PCD FIPE NO PPR-21-036

180649
SHEET NO.
C-07
of 8

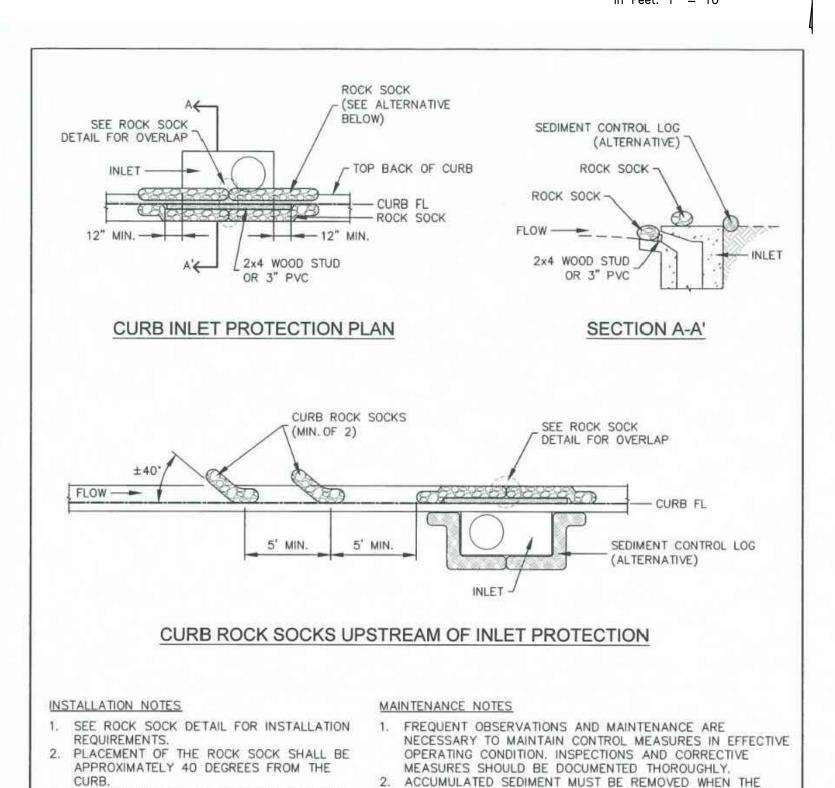
replace with EPC approved VTC detail (VT-1 and VT-2 in DCMv2, Chap 3.3) or revise to be 75ft min length
